CADDISFLY

SLEEVE + CARTRIDGE

V 1.0.3
VERSION NO.

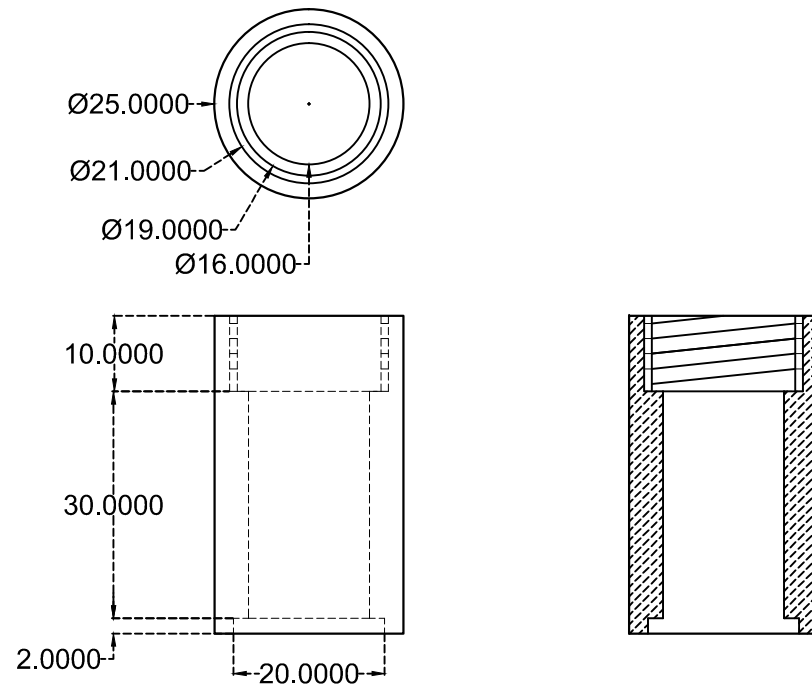
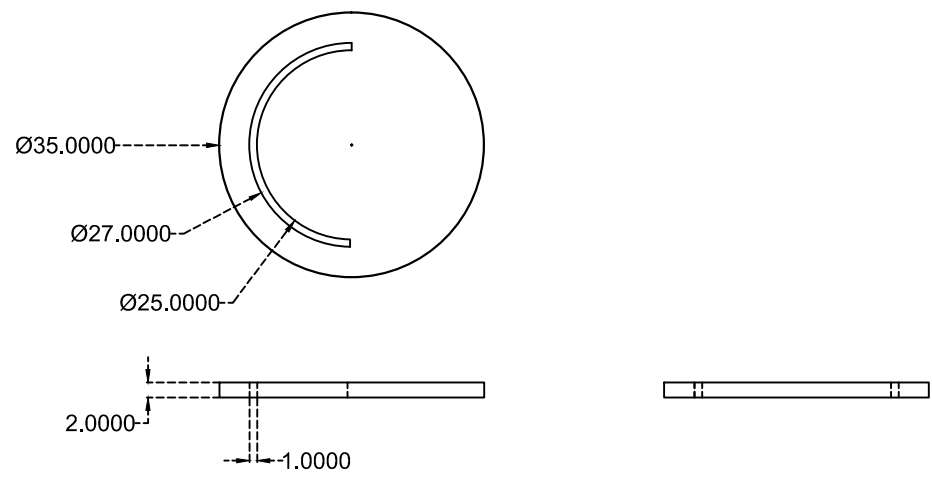
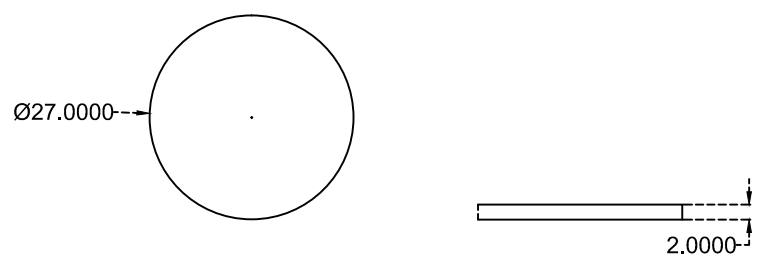
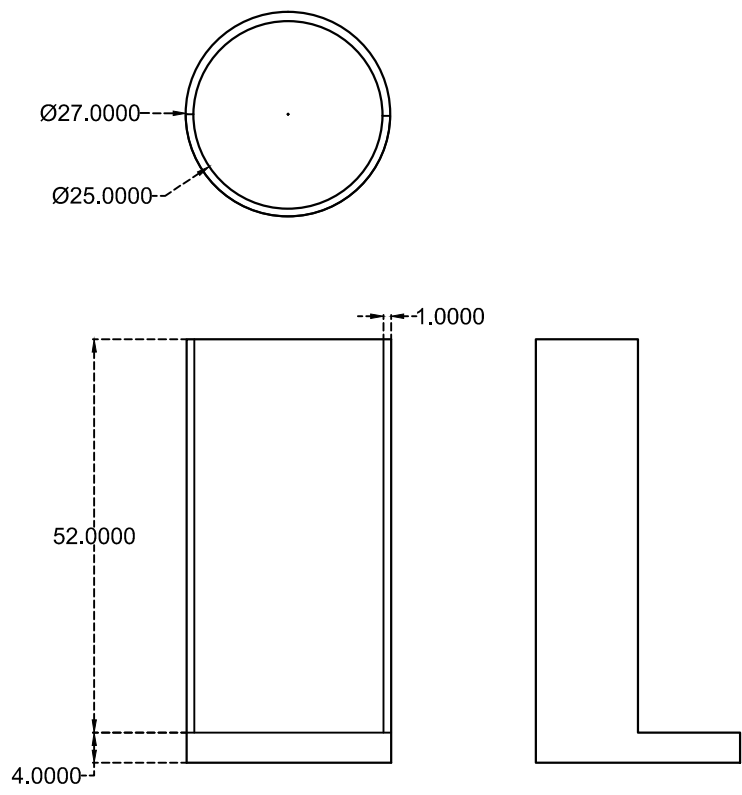
Widened interior diameter of cartridge to improve image quality

Removed sharpened metal ring as reagent capsule hadn't been finalized+space constraint
